Reactor Oversight Process Task Force FAQ Log
January 12, 2017

Dated February 6, 2017

FAQ 16-04, Browns Ferry Safety System Functional Failure

FAQ 17-01
Grand Gulf June 2016 Power Change

PDS Trend Tool

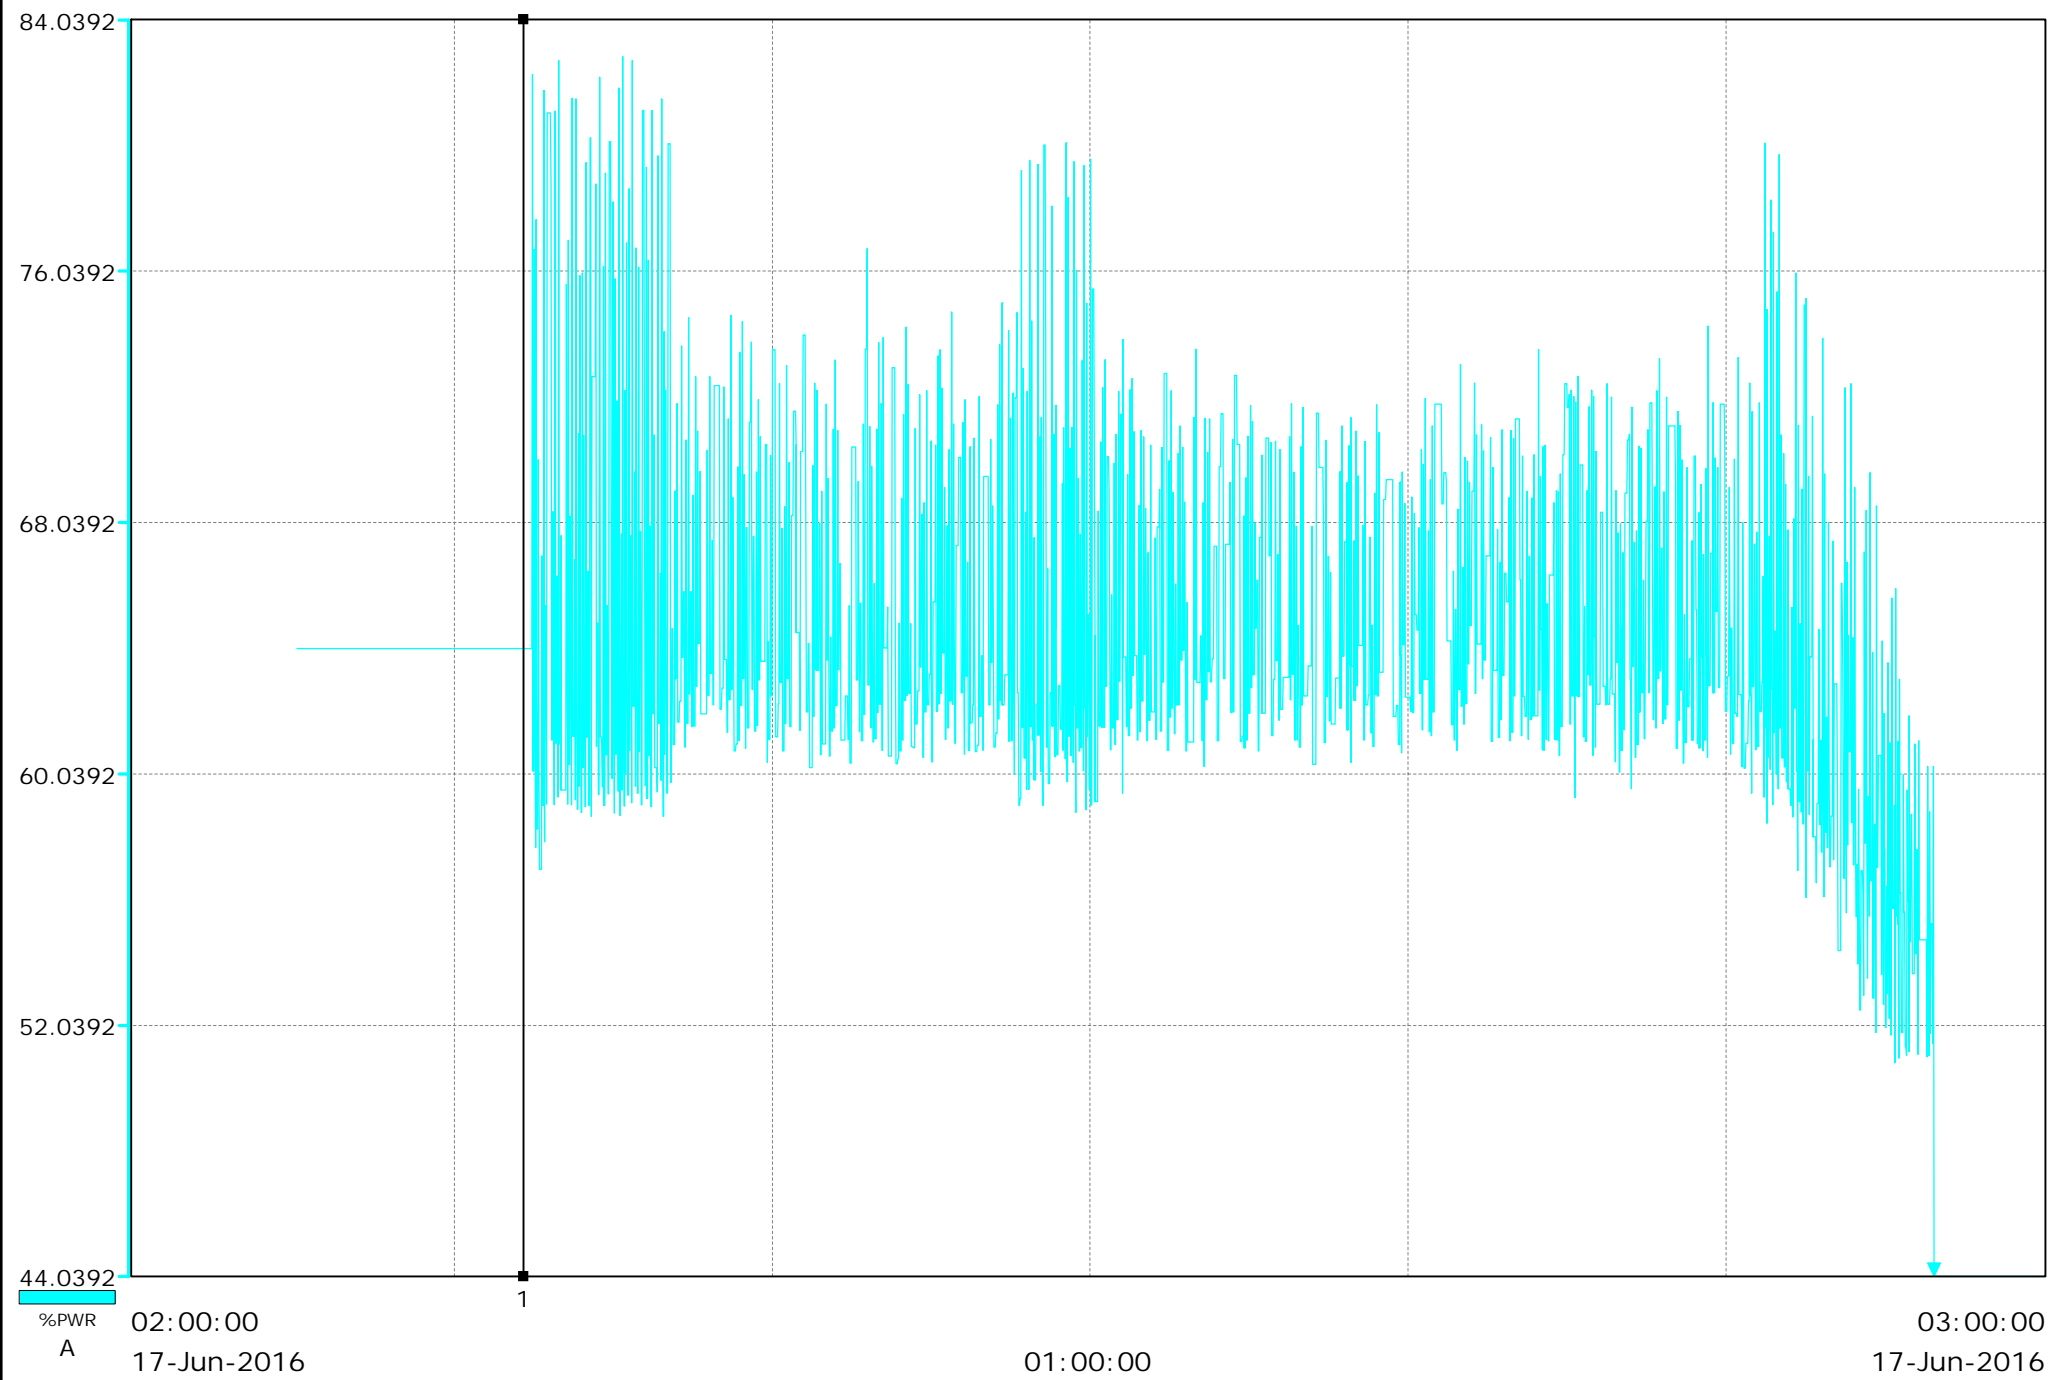
- A Graph showing the power oscillations. The graph depicts magnitude of the y-axes and the time on the x-axes.

The NRC inspectors at the Grand Gulf Nuclear Station, however, do not agree with the licensee's determination that this event is only counted in the Unplanned Scrams per 7000 Critical Hours performance indicator. The NRC inspectors' position that NEI 99-02, Revision 7, guidance would cause the licensee to count this series of events in both the Unplanned Scram, per 7000 Critical Hours and Unplanned Power Changes per 7000 Critical Hours performance indicators:

The first set of oscillations greater than 20 percent power resulted from the second control valve closure and operator action to maintain the manual push buttons depressed on the solenoid valves. The control rooms' decision to hold the manual push button on the solenoid valve depressed resulted in approximately five minutes, of power oscillations of greater than 20 percent power. When the manual push button on the solenoid valve was depressed, the operators were unknowingly diverting electrohydraulic system flow, which challenged the control valves ability to stabilize steam flow when

two stop valves were closed. Operators then decided to release the manual push buttons and the power oscillations reduced to approximately 10 percent. This response demonstrated that the second control valve closure and the pressure control system issue resulted in power oscillations that were limited to only 10 percent. The operator actions to maintain the manual push button depressed caused power oscillations that were greater than 20 percent power.

The second set of power oscillations of greater than 20 percent was caused by operator actions to troubleshoot the issue by attempting to reset and reopen a control valve using the slow closure method with a different solenoid valve. When the desired plant response was not achieved; operators backed out of the troubleshooting efforts, and the power oscillations returned to approximately 10 percent. The third set of increased power oscillations was caused by additional operator actions as attempts were made to troubleshoot the issue by resetting the control valve. These troubleshooting efforts resulted in additional power oscillations of greater than 20 percent. During the control valve reset, operators began to insert control rods with the intention to reduce power and stop the power oscillations. Operators believed that a power reduction to less than 50 percent power would stabilize the plant since two open control valves could pass the resultant steam produced.

Ultimately, operators inserted four control rods, which reduced power and increased the frequency of the power oscillations: Although the magnitude of the power oscillations decreased, the increased frequency of the power oscillations were now in the "counting domain" of the Oscillating Power Range Monitor system, and provided a valid input to the reactor protection system to cause an automatic reactor SCRAM.

Based on the above information and NEI 99-02, Revision 7, the inspectors' position is that the initial cause of the event (an unexpected control valve closure resulting in 10 percent power oscillations) was not the cause of the automatic reactor SCRAM. The reactor SCRAM was a result of operator action to insert control rods as an attempt to reduce power. Also, the cause of the greater than 20 percent power oscillations was a result of repeated operator decisions and actions to conduct troubleshooting activities during a 42 minute period. Therefore; this series of events should be counted in both the Unplanned Scrams per 7000 Critical Hours and Unplanned Power Changes per 7000 Critical Hours performance indicators.

This event should be counted as an unplanned SCRAM. The cause of the power oscillation and ultimately the reactor SCRAM were the same, the unanticipated closure of the second control valve. The conduct of turbine control valve testing in accordance with approved testing procedures combined with an unexpected equipment failure caused the SCRAM.
